Planning and Development Services
Arun District Council
Arun Civic Centre
Maltravers Road
Littlehampton
West Sussex
BN17 5LF

Your Ref
M/99/18/PL
Our Ref
PLAN-024335
Date
13/09/2018

Proposal: 1 No. 2-bedroom dwelling.
Site: 14 Baldwin Close, Middleton-On-Sea, PO22 6RQ.
M/99/18/PL

ARUN DISTRICT COUNCIL M99/18/PL

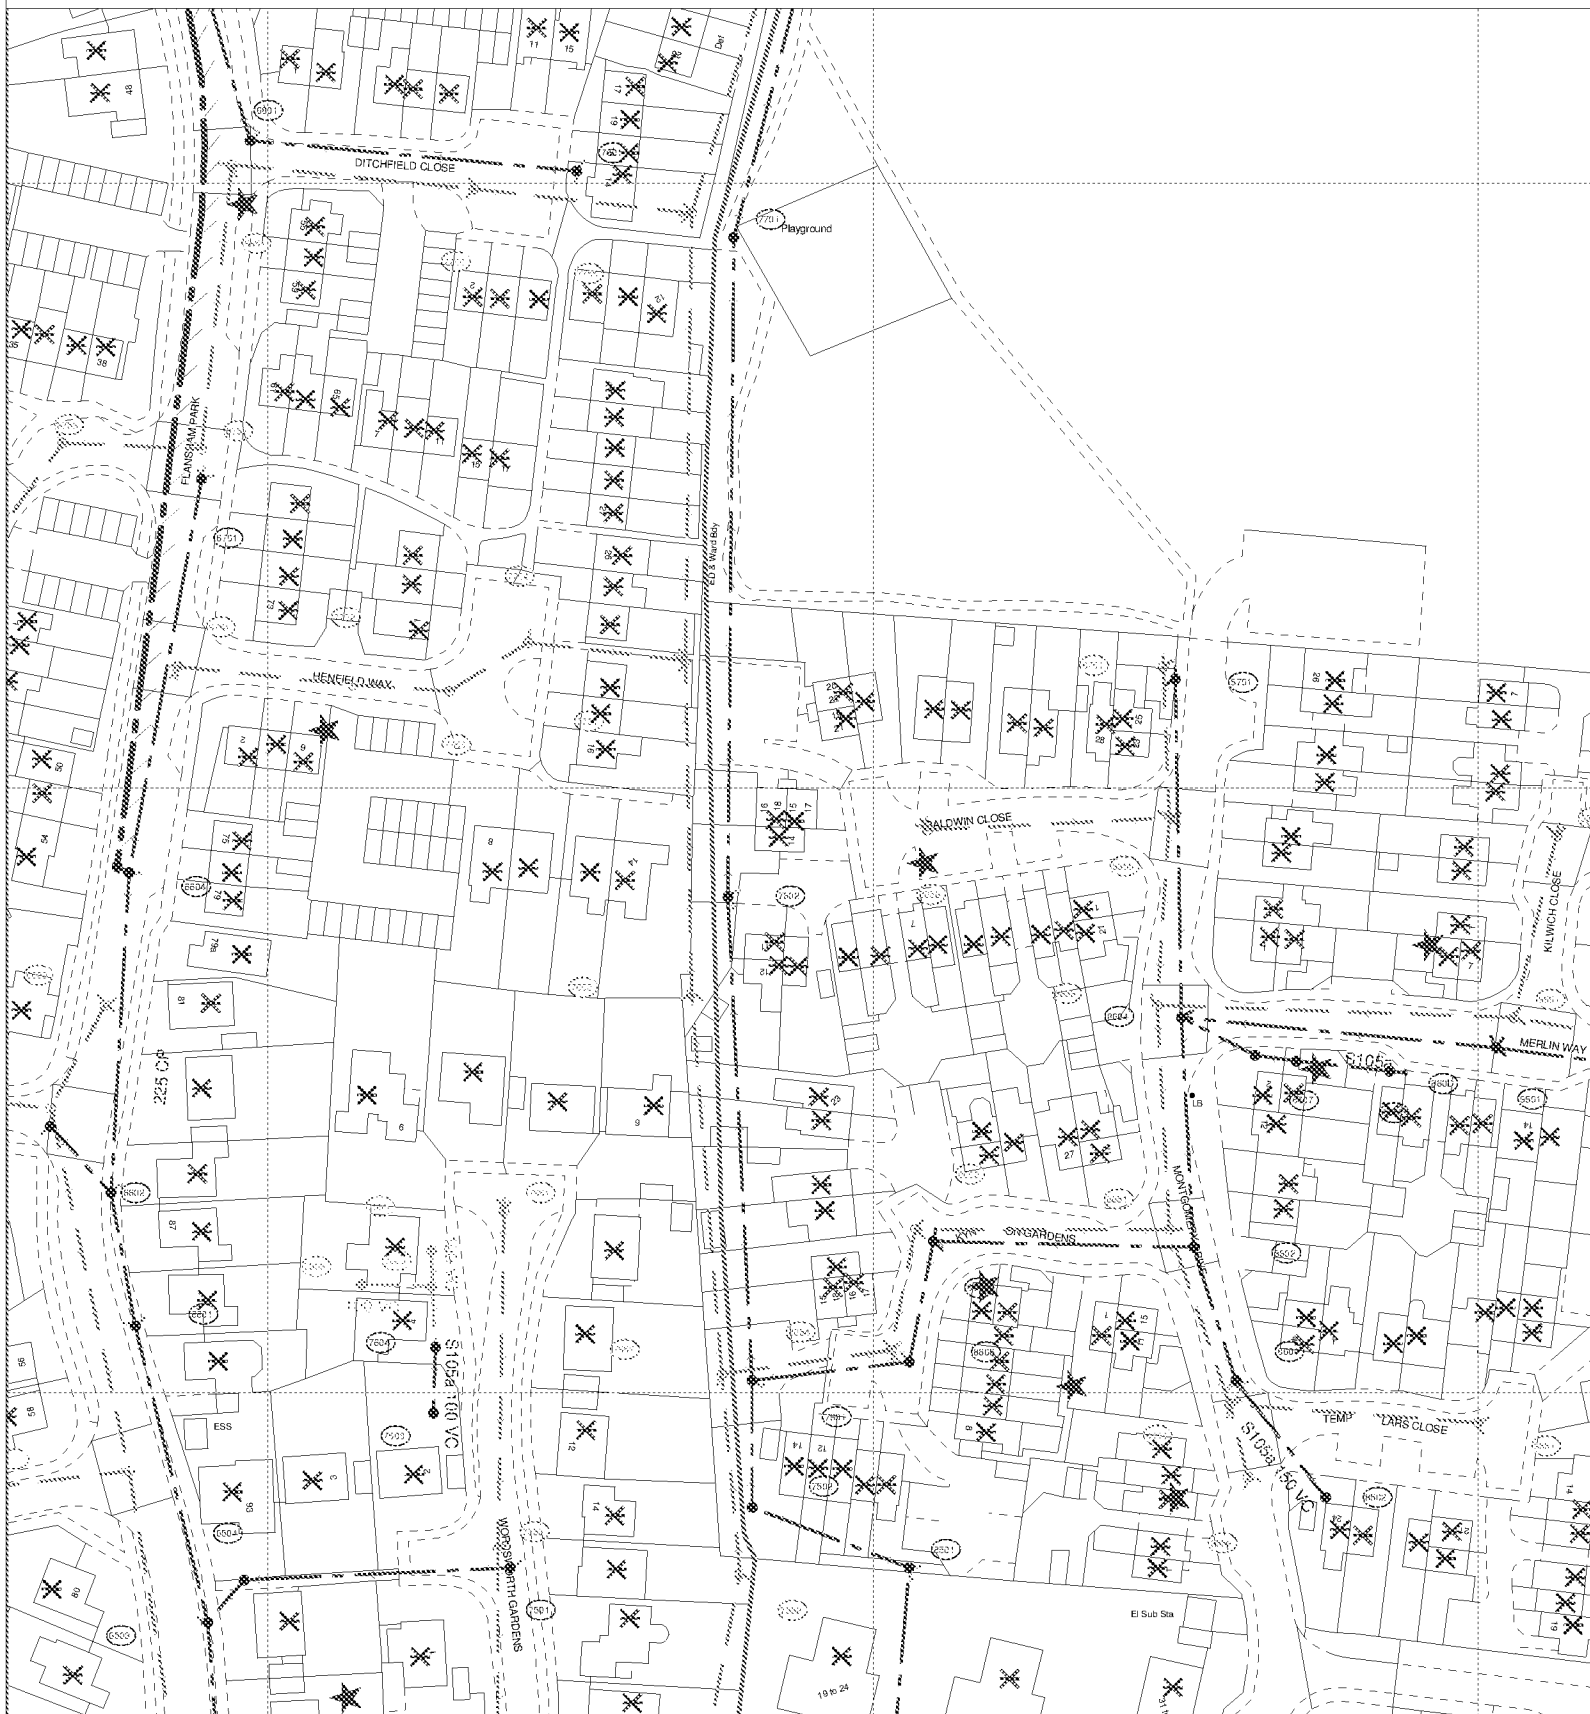
Please find attached a plan of the sewer records showing the approximate position of a foul sewer within the site. The exact position of the public sewers must be determined on site by the applicant before the layout of the proposed development is finalised.

- No development or new tree planting should be located within 3 metres either side of the external edge of the public sewer.
- No new soakaways should be located within 5m of a public sewer.
- All existing infrastructure should be protected during the course of construction works.

In order to protect drainage apparatus, Southern Water requests that if consent is granted, a condition is attached to the planning permission. For example "The developer must advise the local authority (in consultation with Southern Water) of the measures which will be undertaken to protect the public sewers, prior to the commencement of the development."
